PENCLOE WINDFARM

Further Environmental Information Addendum

September 2015

Pencloe Wind Energy Limited

Figure 1 – Revised Site Layout Plan

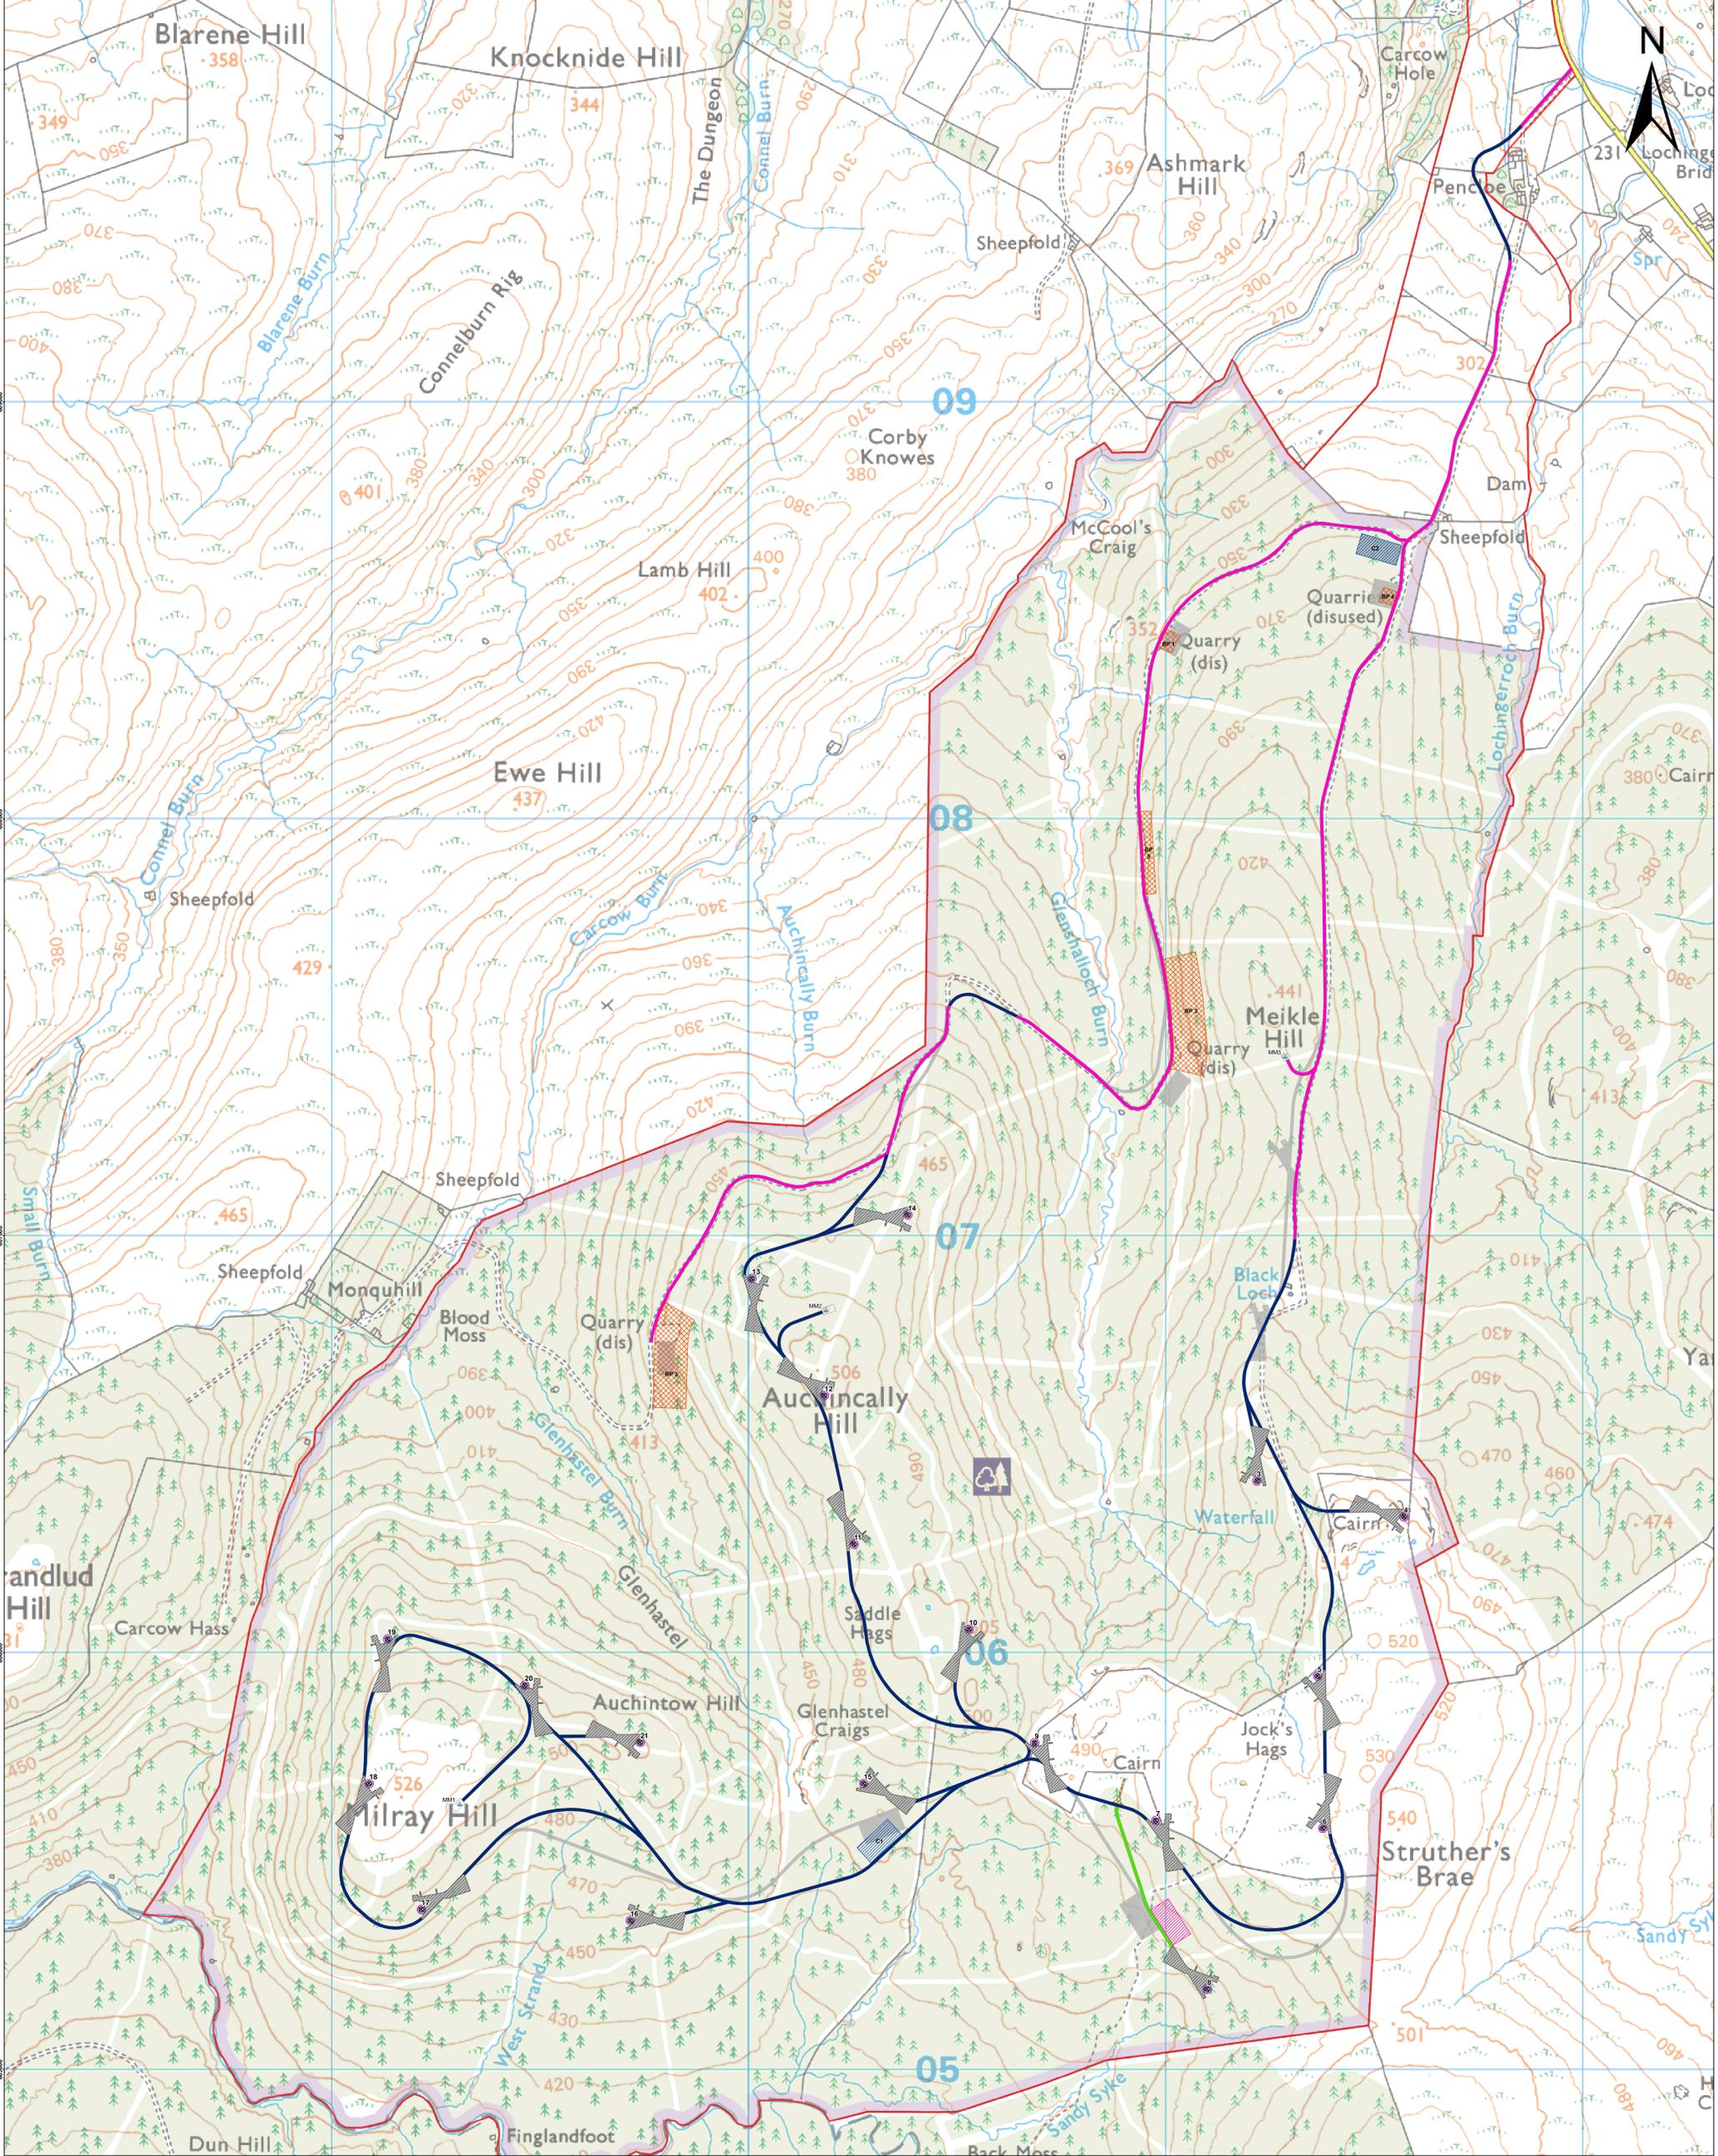
It is no longer proposed that Turbines number 1 and 2 in the March 2015 windfarm layout be constructed. These two turbines have been removed from the layout to address comments made by SNH in their S36 consultation response dated 08/05/15, and a subsequent meeting on 30/06/15. The turbines were removed to improve the appearance of the proposed Pencloe Windfarm when viewed alongside the consented Afton Windfarm from the north, from viewpoints in and around New Cumnock and the southern edge of the town in particular. It is also proposed to microsite turbine 5, again to improve views from New Cumnock and surrounds.

Additional peat depth probing has been undertaken over the proposed development footprint of the windfarm, and this has provided an increased definition of the presence of peat and peat depth (see Peat Depth Survey Report, **Appendix 2**). Some sections of the onsite tracks have been realigned to avoid deeper peat identified as a result of this survey. **Figure 1** shows where realignment has occurred and the previous routing.

It is proposed to re-position the substation compound, which is currently sited to the west of the access track, to the east of the track (see **Figure 1**), this will again avoid an area of deeper peat. This re-positioned site is currently under mature commercial forestry plantation, and away from any mapped watercourses, and no additional significant environmental effects are predicted.
